**Informal Document N° 2**  
(31<sup>st</sup> GRSP, 13-17 May 2002,  
agenda item 1.4)

**Draft Amendments To Regulation No. 17:**  
**(Strength of Seats)**

Annex 2B

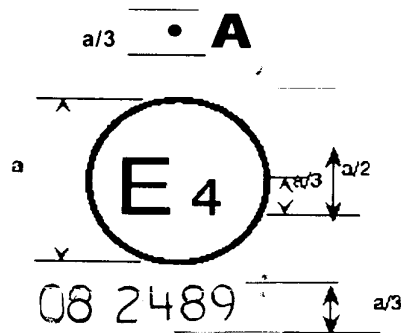
1. Arrangement of the partitioning system approval marks ( see paragraphs 4.2.4.1. and 4.2.5. of this regulation.

The partitioning system bearing the above approval mark is an upper partitioning system ( `A` ) and approved in the Netherlands ( `E4` ) under the number 08 2489, the Regulation already incorporating the 08 series of amendments at the time of approval.

NOTE: The approval number and additional symbol(s) must be placed close to the circle and either above or below the `E` or to the left or right of that letter. The digits of the approval number must be on the same side of the `E` and orientated in the same direction. The additional symbol(s) must be diametrically opposite the approval number. The use of roman numerals as approval numbers should be avoided so as to prevent confusion with other symbols.

Figure 1

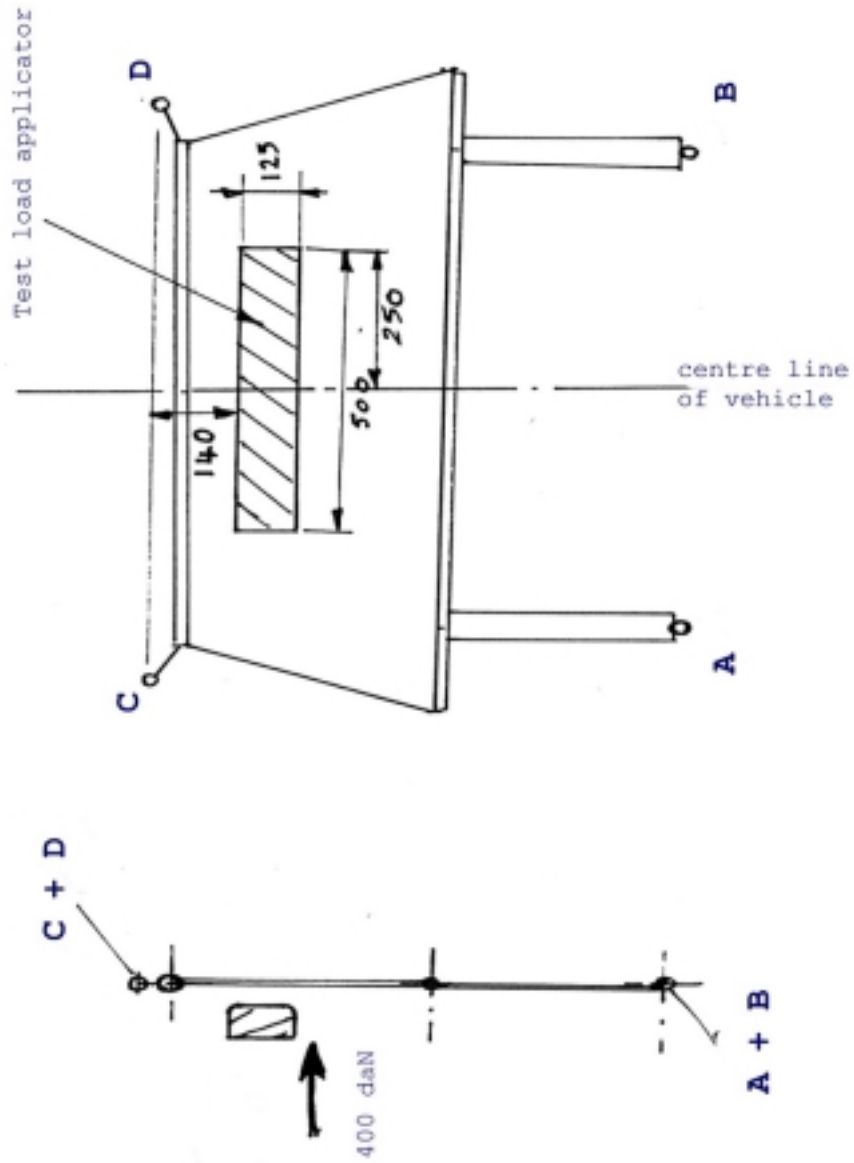
1. Upper Partitioning Systems ( Type A ) Load Application. Referring to figure 1 The test load applicator consists of a rigid panel 500mm. X 125mm. with all edges and corners rounded to a radius of 20mm. This is positioned relative to the partitioning system as shown in figure 1 and a static force increasing to 400 daN is applied to the partitioning system at a speed of application not less than 100mm. per minute. When the prescribed load is reached the force is released.

Figure 2

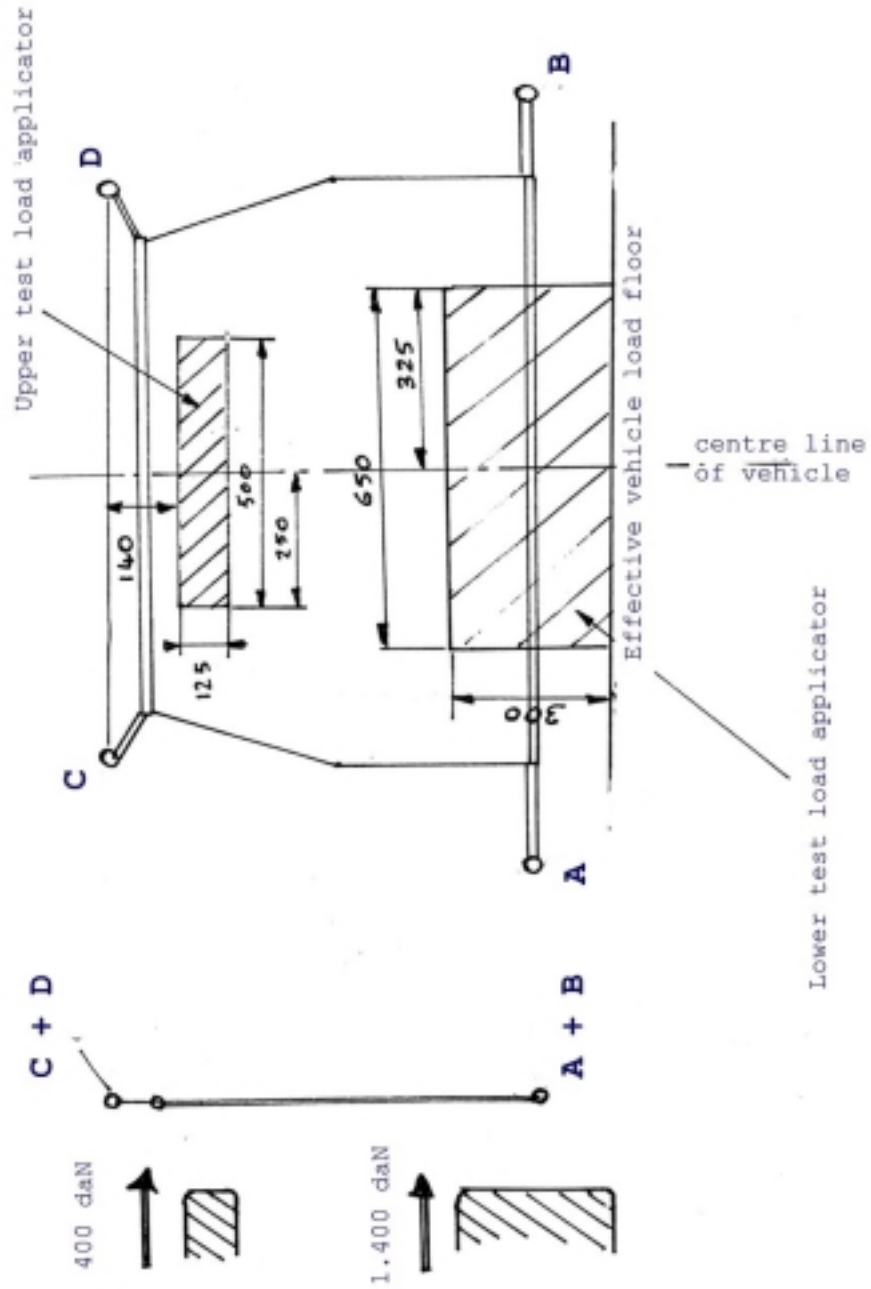
2. Full Partitioning System ( Type B ) Load Application. Referring to figure 2 The upper test load applicator E consists of a rigid panel 500mm.X 125mm. with all edges and corners rounded to a radius of 20mm. This is positioned relative to the partitioning system as shown in figure 2. The lower test load applicator F consists of a rigid panel 650mm. X 300mm. with all edges and corners rounded to a radius of 20mm. This is positioned relative to the partitioning system as shown in figure 2. Simultaneously the load applicators E and F are to be pressed into the partitioning system until the force applied to the upper applicator E reaches a value of 400 daN and the force applied to the lower applicator F reaches 1,440 daN. When the load of each applicator reaches its maximum value the load is to be released. The speed of application of the load is to be not less than 100mm. per minute in all cases.

Diagram of an apparatus to test  
the strength of partitioning systems

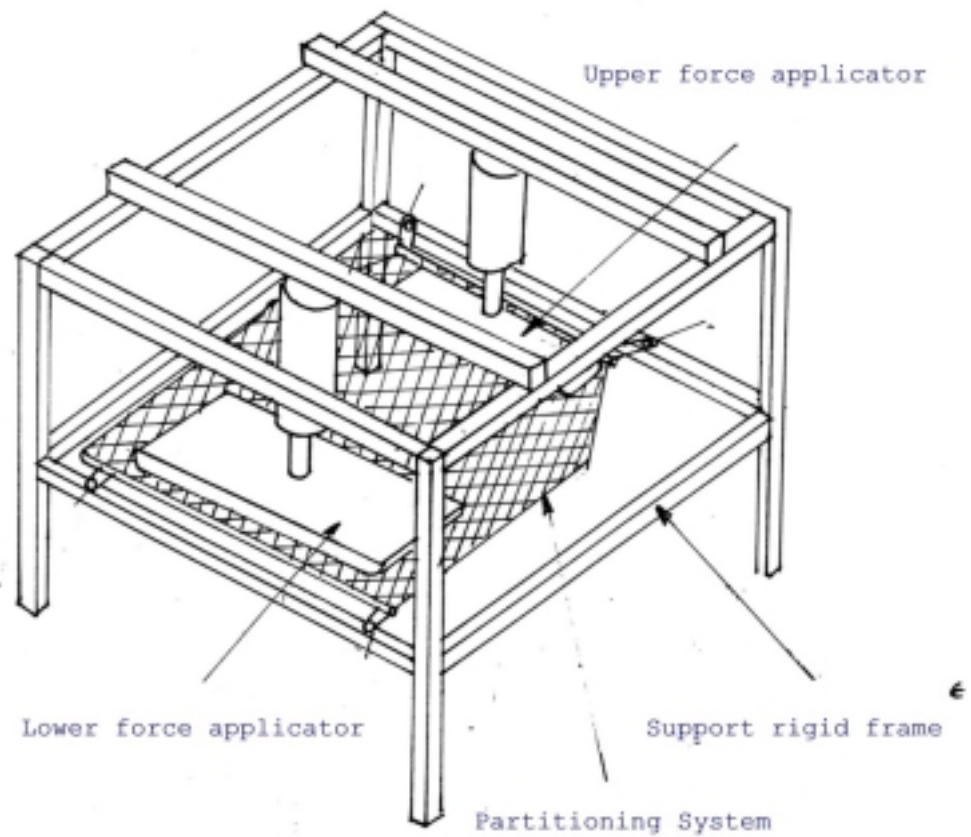
The partitioning system must be attached to a substantially rigid frame with the attachment hardware supplied by the manufacturer. At the discretion of the technical service performing the test the attachment points A,B,C and D should replicate the geometry of the intended vehicle attachment points or the worst case positions of the proposed installation positions recommended by the partitioning system manufacturer. All attachment straps and hardware etc. should be fitted in accordance with the manufacturer's instructions. See figure 1 and 2.
